DESCRIPTIVE REPORT

Job No.PH-6702..... Map No. T-11865(2)

Locality Gulf of Santa Catalina

REVIEW REPORT

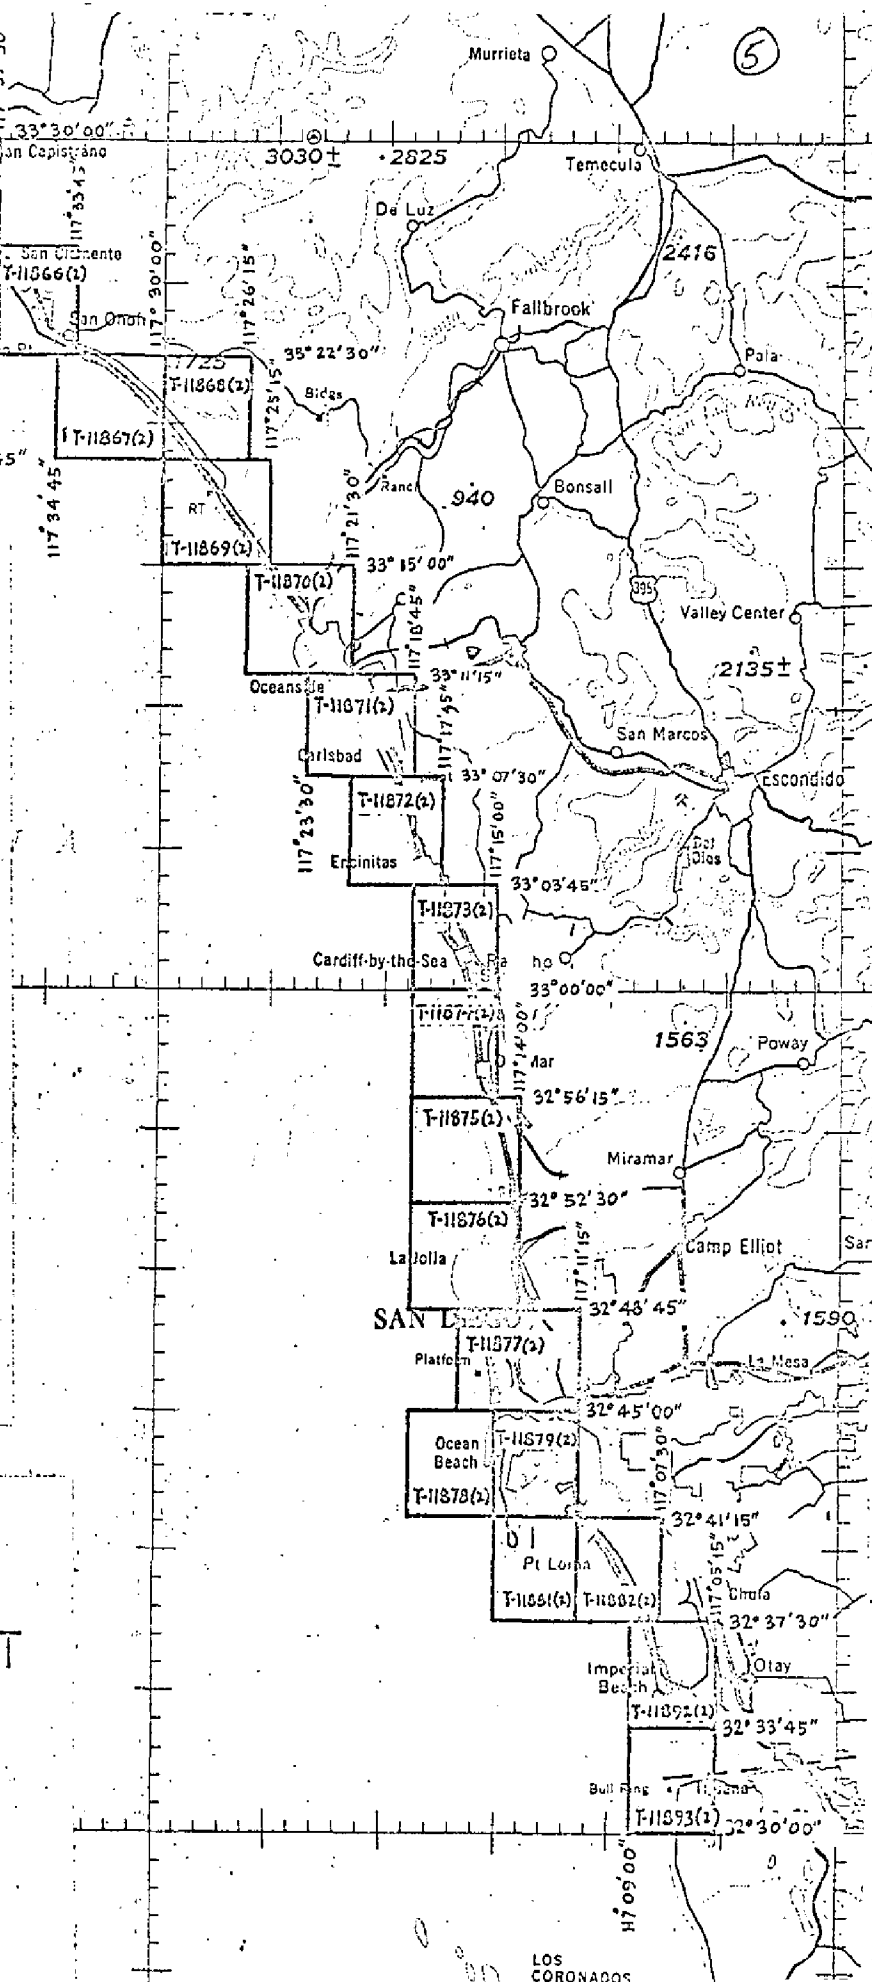
Sheet Nos.	Area Sq. Mi.
T-11864 (2)	2
T-11865 (2)	1
T-11866 (2)	3
T-11867 (2)	3
T-11868 (2)	1
T-11869 (2)	3
T-11870 (2)	3
T-11871 (2)	3
T-11872 (2)	2
T-11873 (2)	2
T-11874 (2)	2
T-11875 (2)	2
T-11876 (2)	3
T-11877 (2)	6
T-11878 (2)	2
T-11879 (2)	5
T-11881 (2)	2
T-11882 (2)	4
T-11892 (2)	5
T-11893 (2)	2
Total	56
